**CITY OF SUMMERSET PLANNING AND ZONING BOARD
ONLINE ZOOM MEETING
REGULAR MEETING
7055 LEISURE LANE
TUESDAY APRIL 14, 2020
6:00 P.M.**

Project: Lots 17-19, Block 1; Lots 5-8, Block 2; and Lots 1-12, Block 5; and Dedicated Public Right-of-way for Glenwood Drive and Arapahoe Street of Sun Valley Estates

Subject: Preliminary Plat Review

PROJECT: Sun Valley Estates Subdivision Phase 2
LOCATION: Summerset, South Dakota
DATE: April 10, 2020
TOPIC: Responses to Preliminary Plat Review Comments

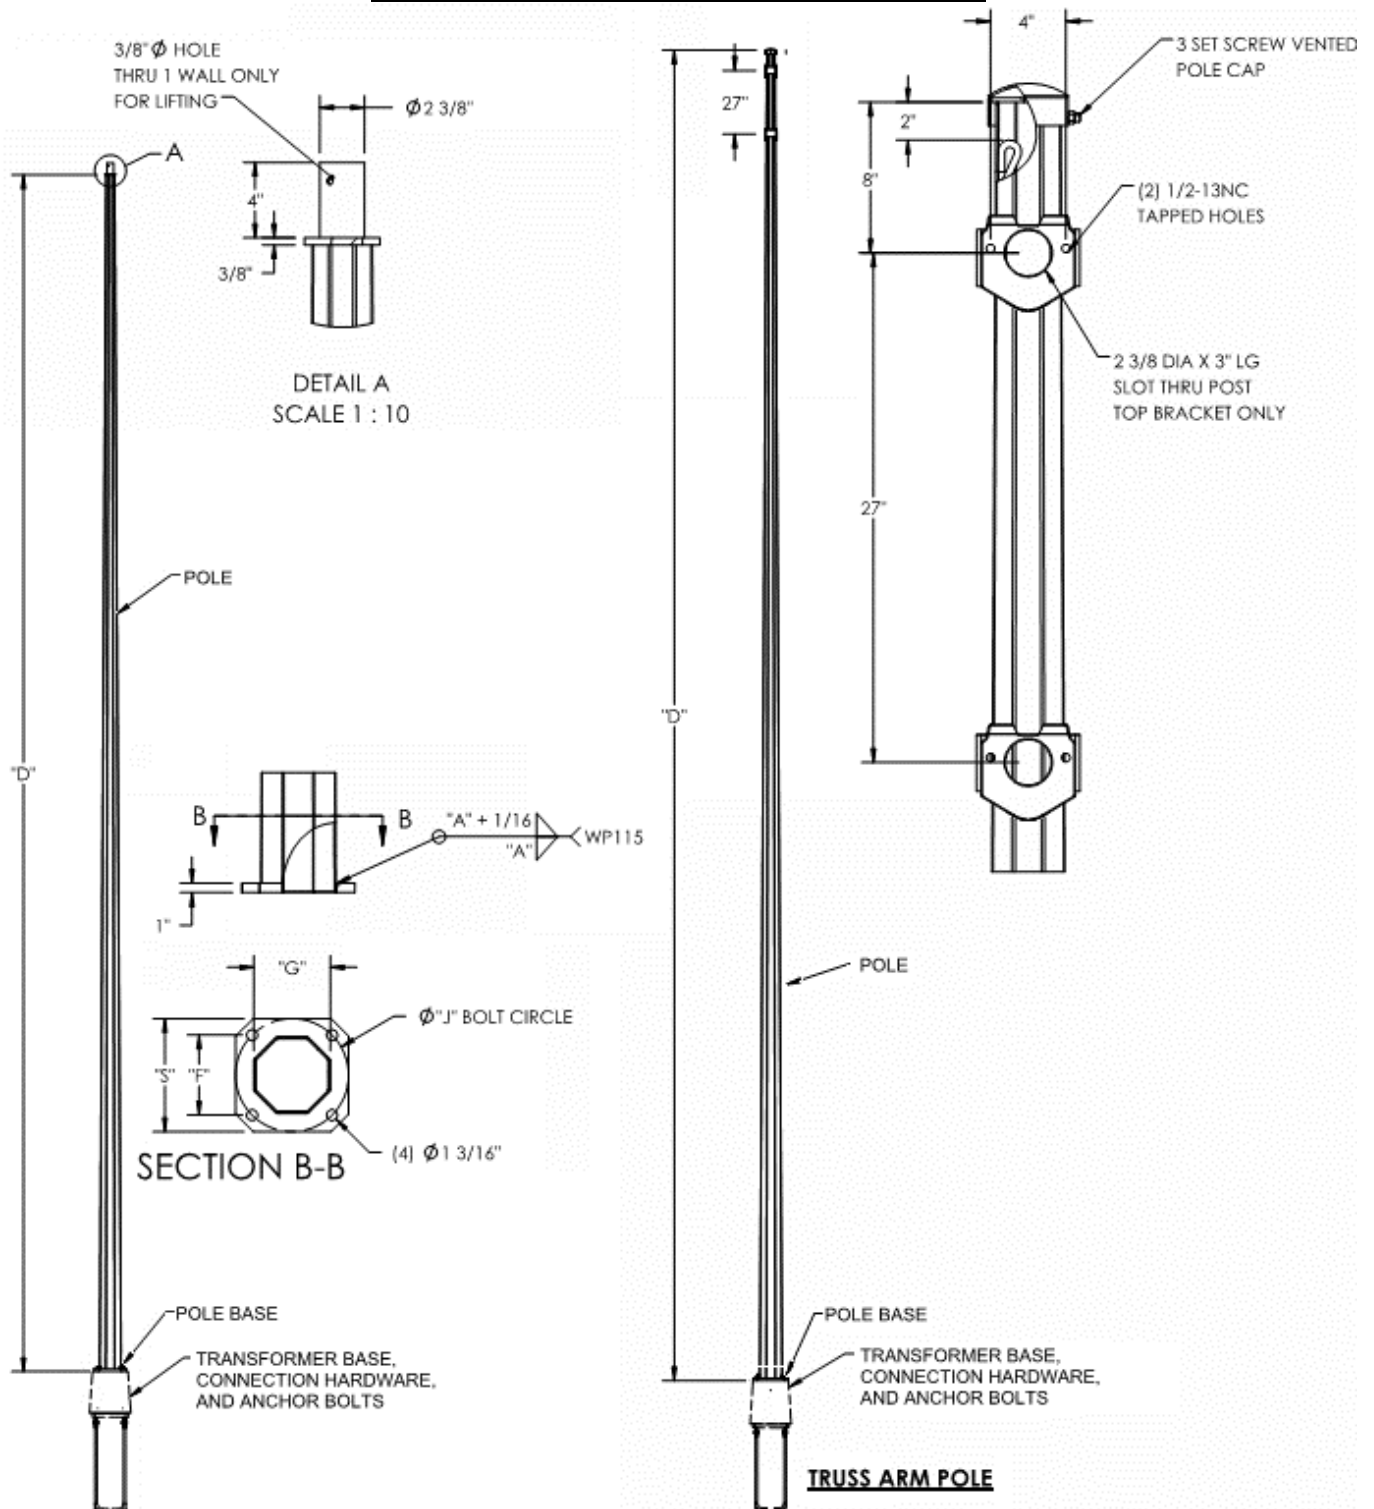
8. Why is there such a steep grade in the sewer between the existing manhole in Glenwood and Manhole #1?

8. Why is there such a steep grade in the sewer between the existing manhole in Glenwood and Manhole #1?

Response: This location is the transition point to allow the new sanitary sewer main to be located at a responsible depth of 9' not 14'+. Based on future phasing, this will support future expansion of Glenwood and Arapahoe as well.

Detail for 8' Arm

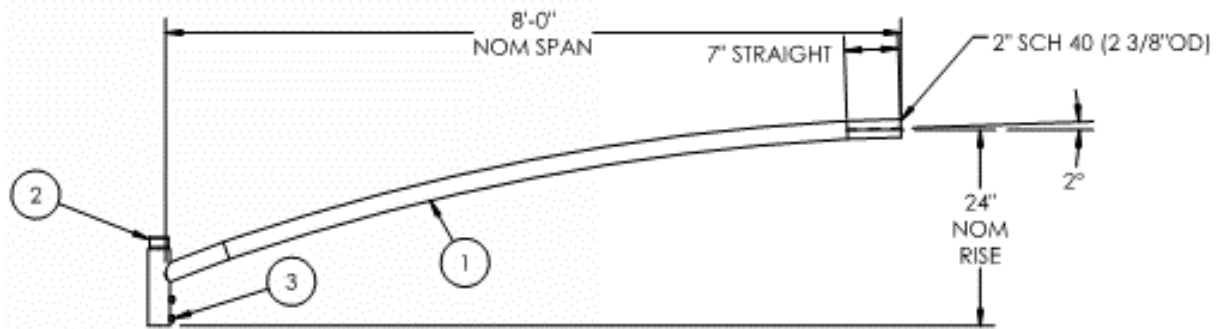
4. Summerset has new lighting design standards that need to be incorporated into the plans:
 - a. 30' tall w/ 8' arm extension
 - b. 40 watt LED
 - c. direct bury style
 - d. poles shall be galvanized steel material as manufactured by HAPCO, Millerbernd, and Valmont
 - e. 185' spacing, with poles placed at intersections and curves
 - f. placed in line with property lines and 2' off the back of curb for boulevards and 1' off sidewalk for curbside sidewalk
 - g. light pole details attached

Response: New lighting standards have been incorporated.
